29 May 2015

**Subject: Phase 2 Site Investigation Work Plan Addendum
Crystal Geyser Roxane – Spring Water Bottling Facility
1210 South US Highway 395
Olancho, California**

Figure 1 Proposed Phase 2 Monitoring Well Locations

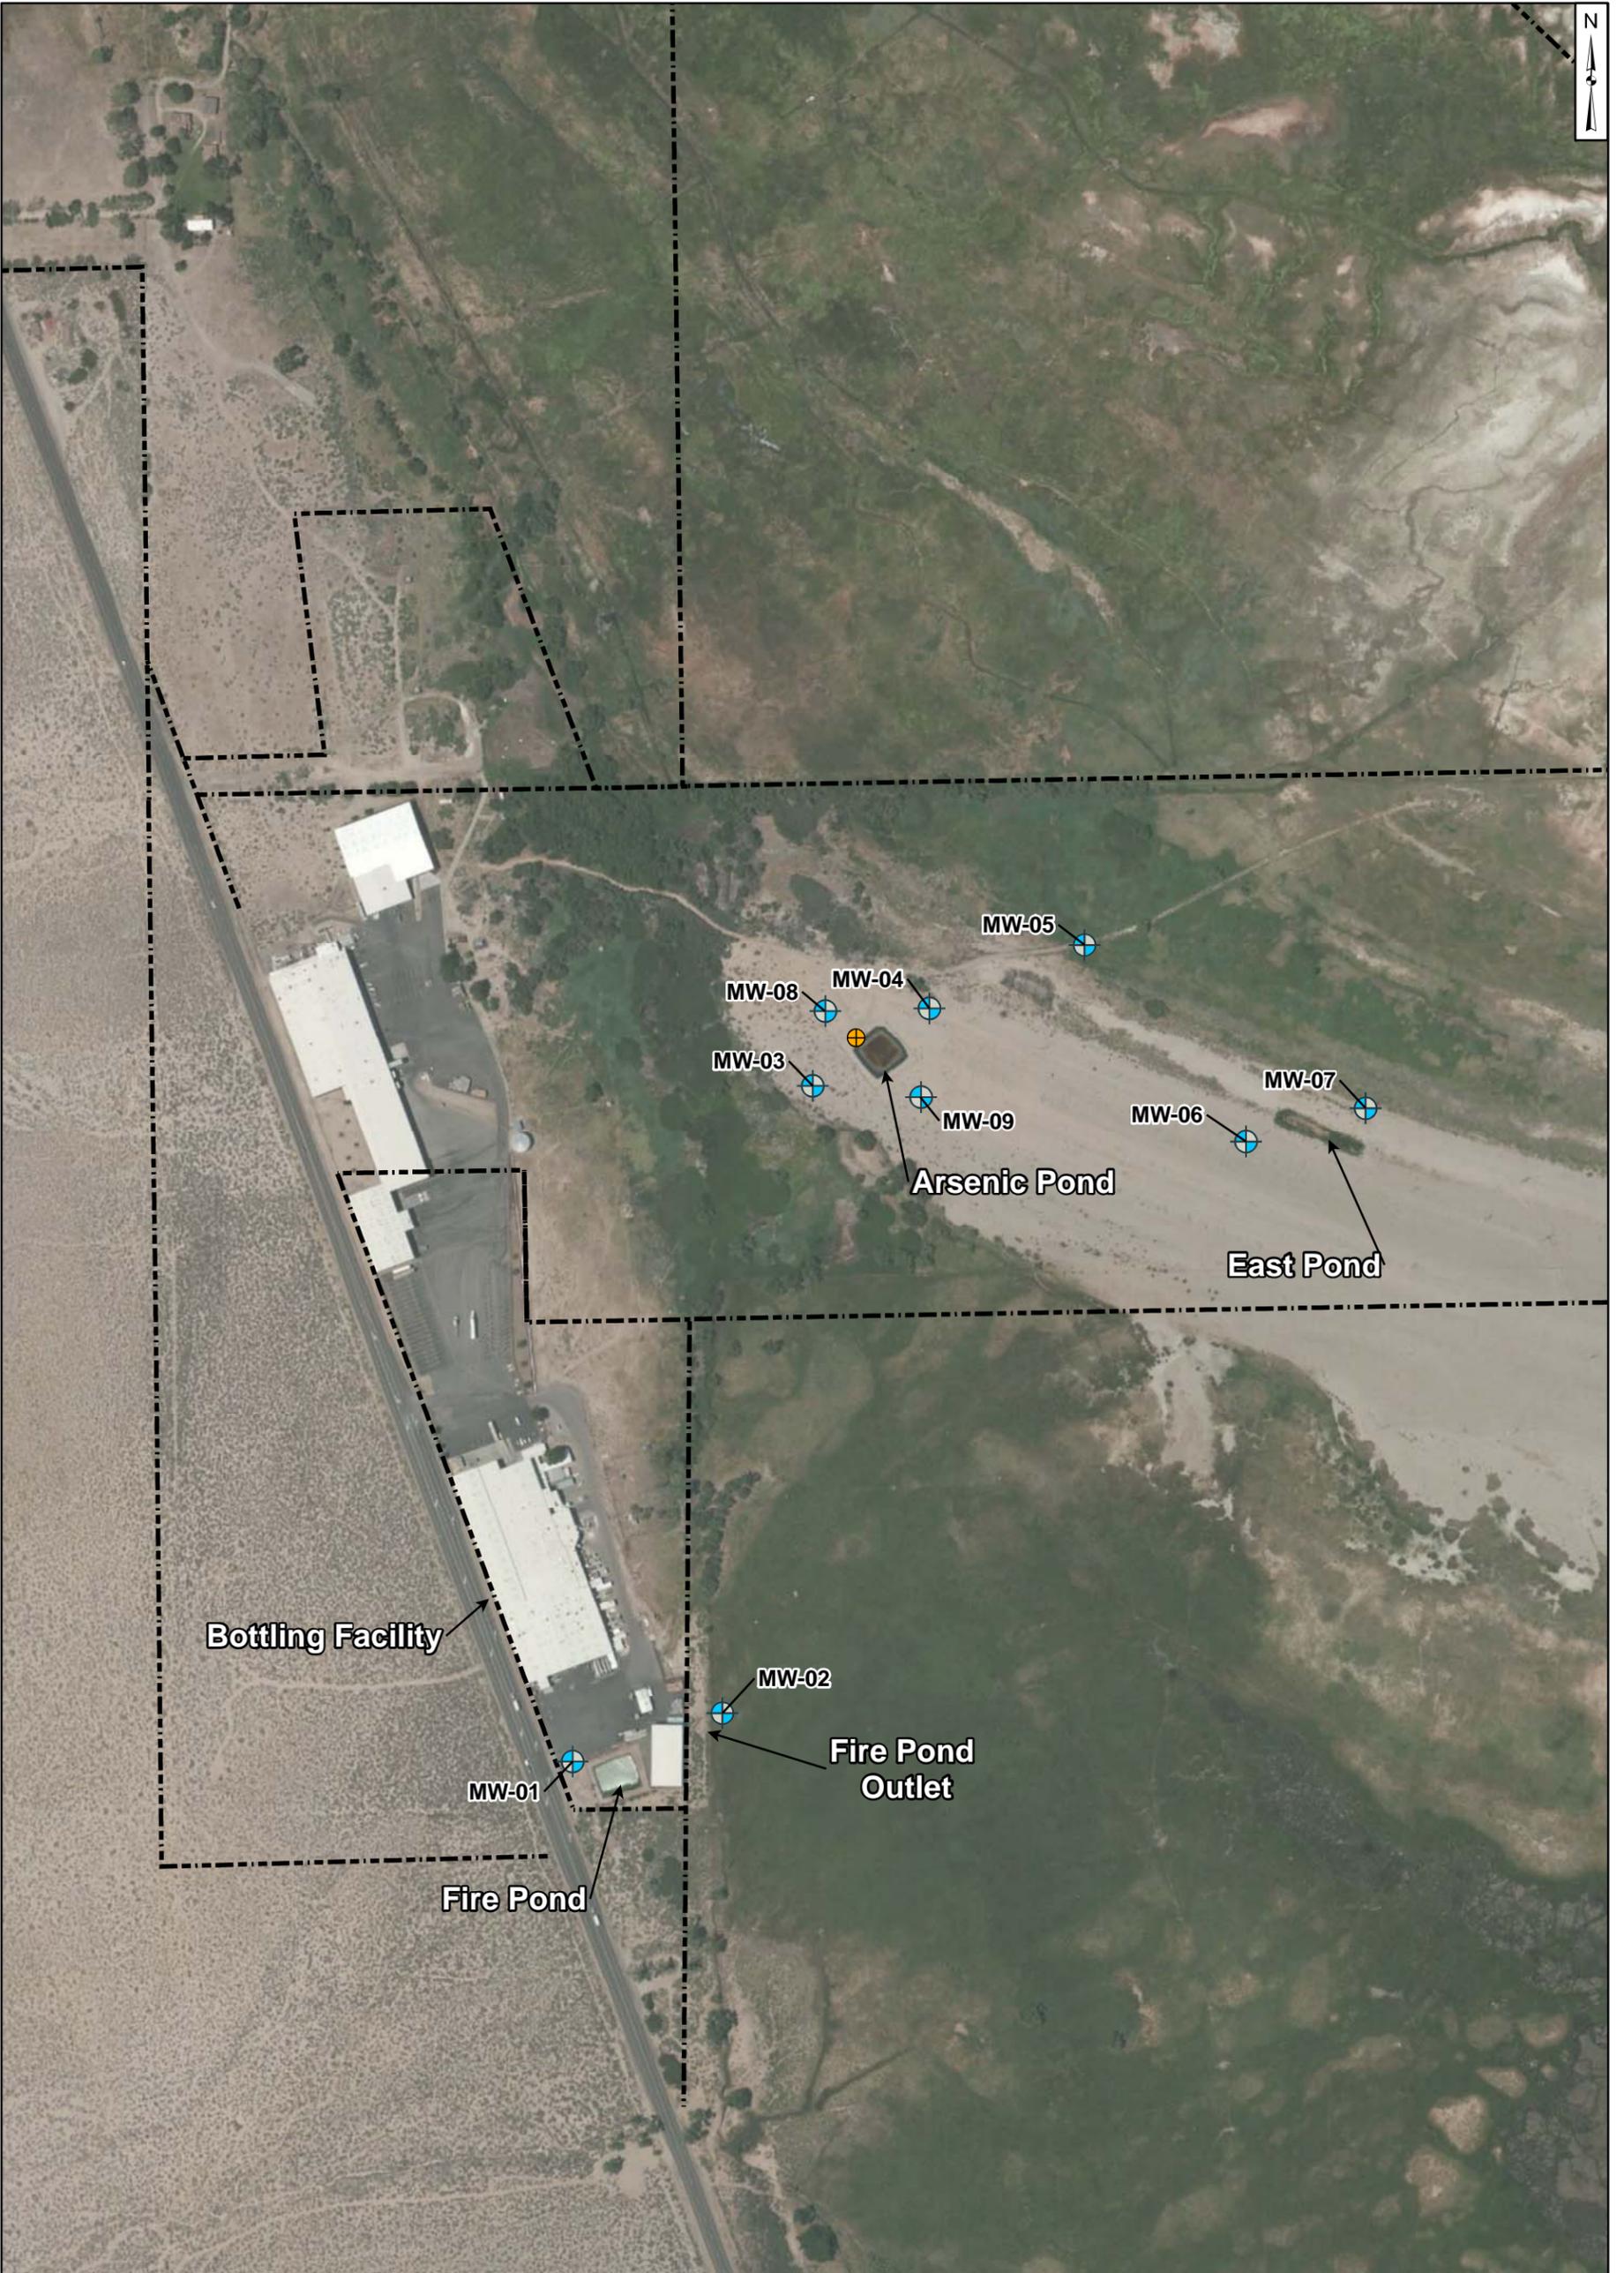
Comment 1. Water Board staff recommends at least two (2) additional groundwater monitoring wells at locations cross-gradient of the Arsenic Pond (one generally to the northwest and one to the southeast) be included in the Phase 2 investigation, in order to begin assessing the lateral extent of groundwater pollution and degradation documented in that area.

Comment 2. At least one (1) additional soil boring/hydropunch groundwater sampling location is needed adjacent to, and down-gradient from, the wastewater valve distribution box near the Arsenic Pond, where “pH neutralization” activities occur during arsenic treatment system regeneration. The additional boring/hydropunch is necessary to assess whether adverse impacts to soils and/or groundwater have results from either (1) potential leakage from the distribution box, or (2) potential spillage of the highly caustic and corrosive materials or solutions/dilutions thereof (“neutralizing solutions”) that are injected into the distribution box to neutralize wastewater discharges to the Arsenic Pond.

Monitoring wells MW-08 and MW-09 have been added to the monitoring well installation schedule. These wells are shown on **Figure 1** attached with this Addendum.

Boring AP-4 will be completed in a similar methodology to Phase 1 investigation borings. The boring is shown on **Figure 1**, and will be located adjacent and down-gradient of the valve distribution box. The boring will be completed using a hollow stem auger drilling rig. Continuous soil samples will be collected using a modified split spoon sampler to obtain lithologic data and potential indications of contamination. Once the groundwater table is encountered, a Hydropunch™ sampler will be driven approximately 2 feet below the groundwater table and a groundwater sample will be collected.
